DEVIATION REQUEST AND DECISION FORM

Project Name : Grandwood Ranch
Schedule No.(s) : 6119000003
Legal Description : S2N2, EX PT TO HIGBY RD CONV BY REC# 205092691 W/MR SEC 19-11-66

DEV #5

PCD File No. SP-195

Deviation Exhibit 3
**Centerline
Roadway Grades**
Grandwood Ranch (LSC# 185020)

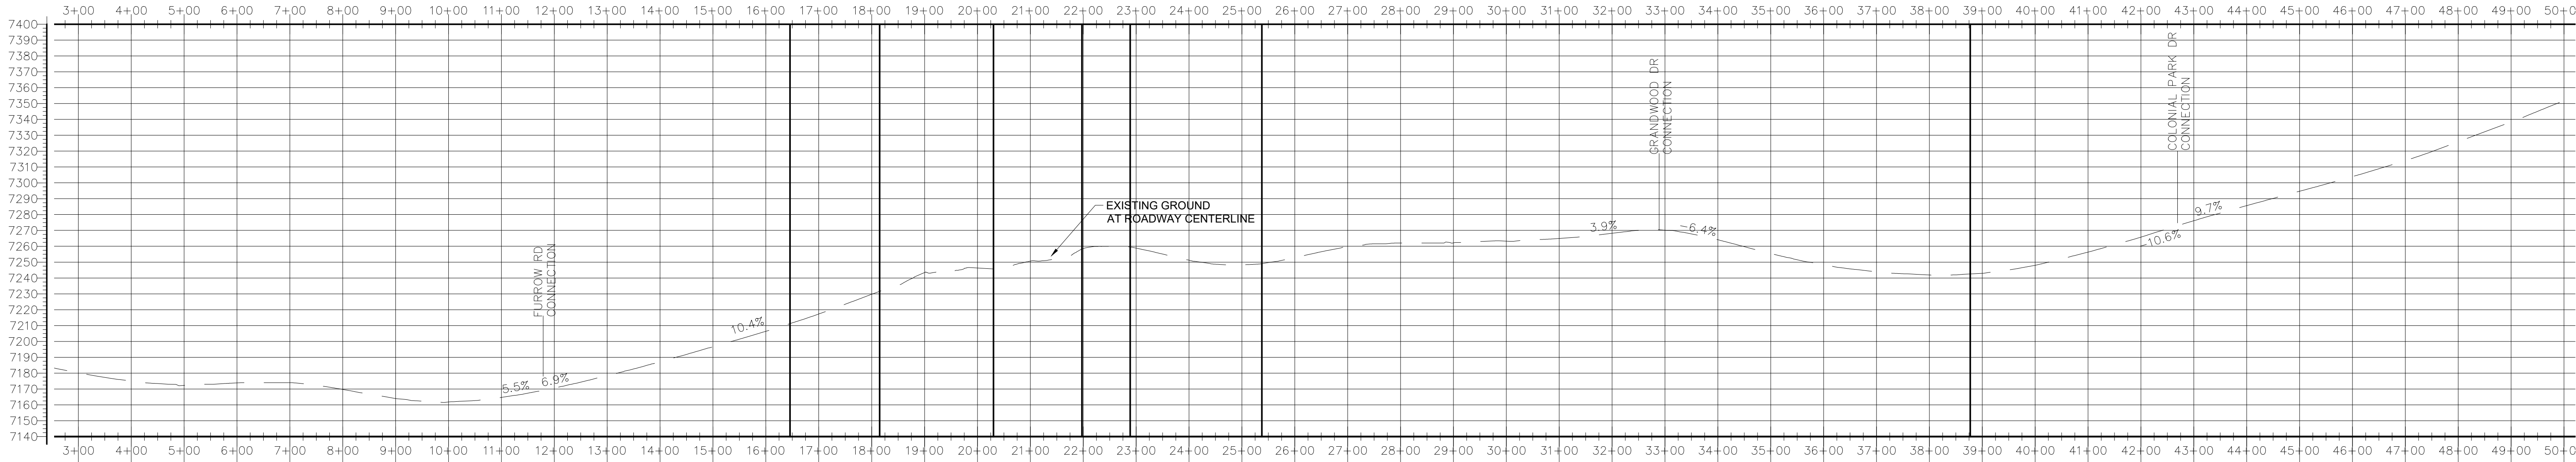
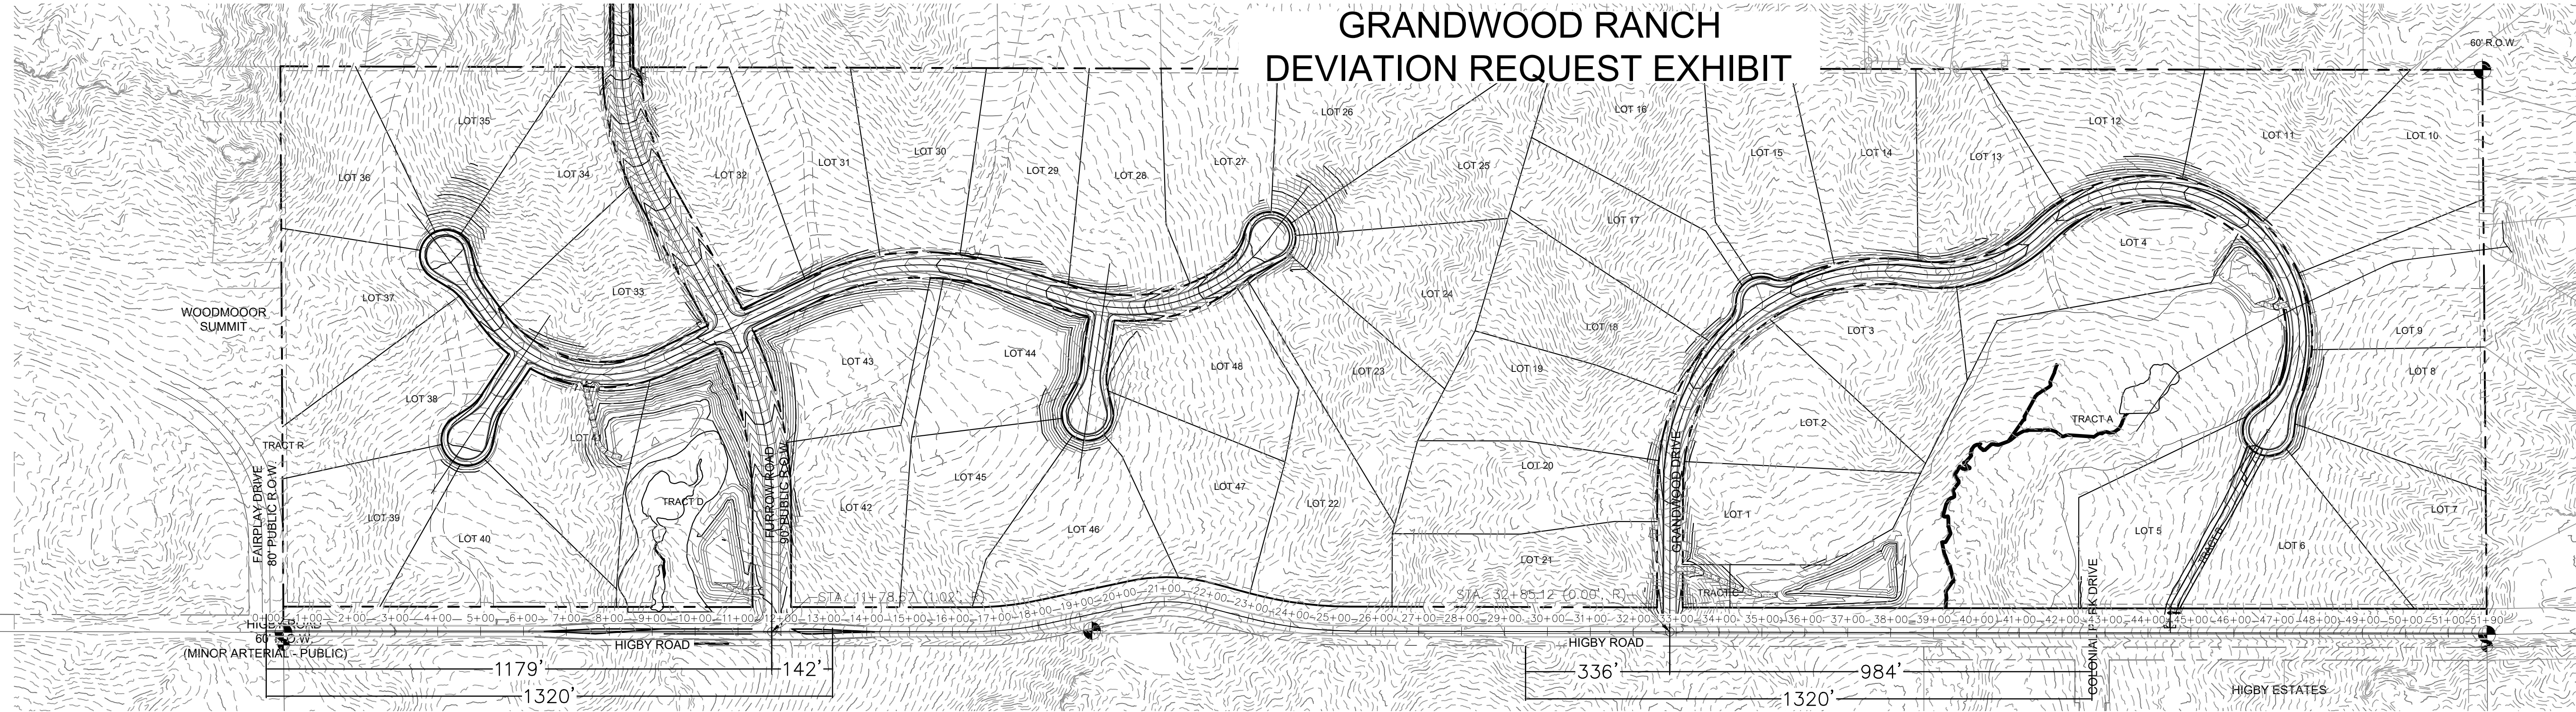
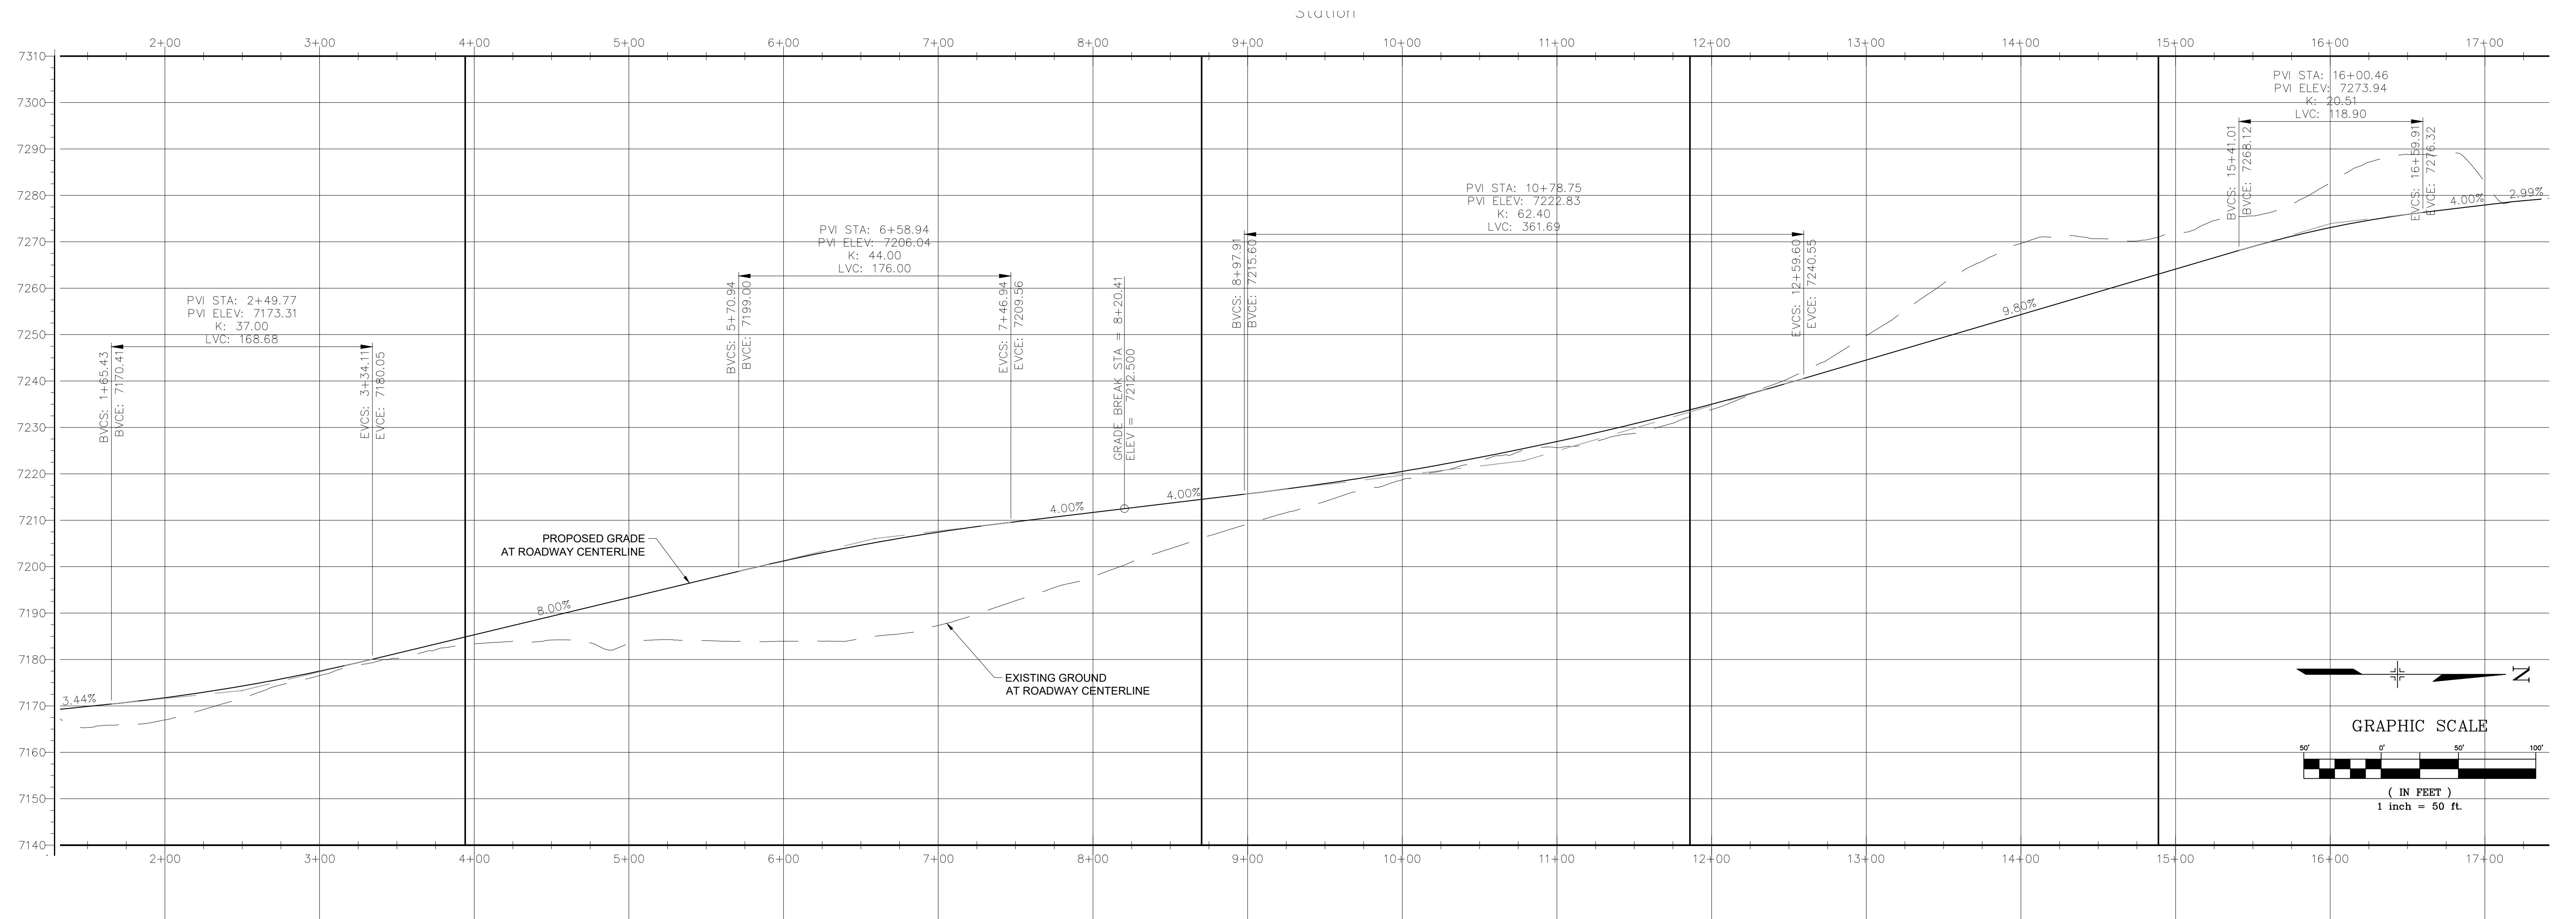
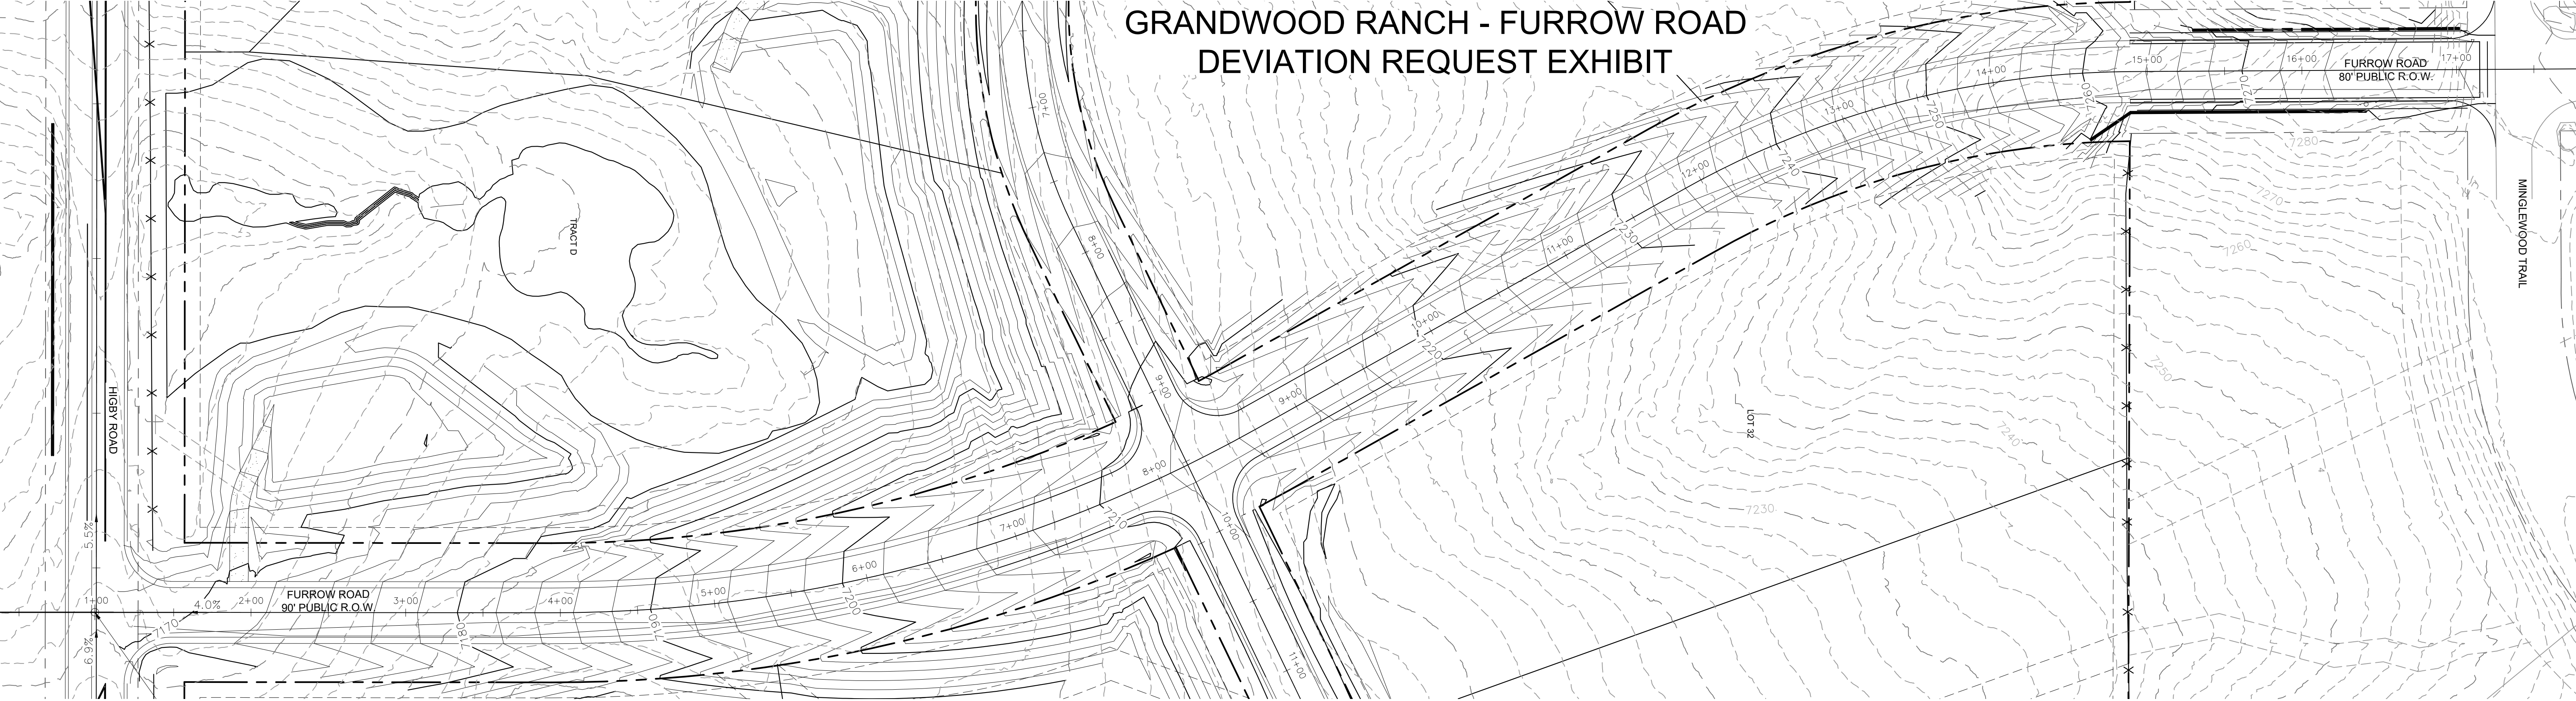
The design plans were prepared to minimize the intersection approach grades and roadway centerline grades. However, the natural grade is approximately 10% for about 900 to 1,000 feet south of Minglewood Trail. The change in elevation between the current terminus of Furrow Road (at Lamplight) and Higby Road and the horizontal distance between these two locations requires a deviation to the centerline roadway grade.

- North of the intersection (between the intersections of Copper Valley Court and Minglewood Tr.), the centerline roadway grade is proposed to be 9.8%

- The proposed westbound approach to the Higby Road/Furrow Road intersection is about 6.5 percent
- West of the proposed intersection, the grades moderate for the eastbound intersection approach at approximately 5.5 percent.

The proposed "mid-block" centerline roadway grade north of the intersection (between the intersections of Copper Valley Court and Minglewood Trail) would exceed the ECM maximum. The centerline roadway grade is proposed to be 9.8%. The ECM standard for Rural Collectors is 8% maximum (10% maximum grade permitted at the discretion of the ECM Administrator). The proposed section of 9.8% grade would exceed the 8% standard by 1.8%. The proposed 9.8% meets (by 0.2%) the allowable maximum grade permitted with ECM Administrator approval (10%). See the attached deviation exhibit and the attached plan and profile exhibit prepared by Matrix Design Group.

- The westbound approach grade to the proposed Higby Road/Furrow Road intersection would be about 6.5 percent.
- West of the proposed intersection, the grades moderate for the eastbound intersection approach at approximately 5.5 percent..

Furrow Road between Higby Road and the south terminus of Furrow Road at Minglewood Trail are "fixed" points in terms of elevation and the horizontal distance between. The natural grade is approximately 10% for about 900 to 1,000 feet south of Minglewood Trail. Given the change in elevation between the current terminus of Furrow Road (at Minglewood/Lamplight) and Higby Road and the horizontal distance between these two locations, a deviation is required to the centerline roadway grade to meet the intersection grade standard at the proposed Furrow Road/Copper Valley Court intersection.

This request has been determined to have met the criteria for approval. A deviation from Section _____ of the ECM is hereby granted based on the justification provided.

2.3.4.B and 2.3.7.C.4
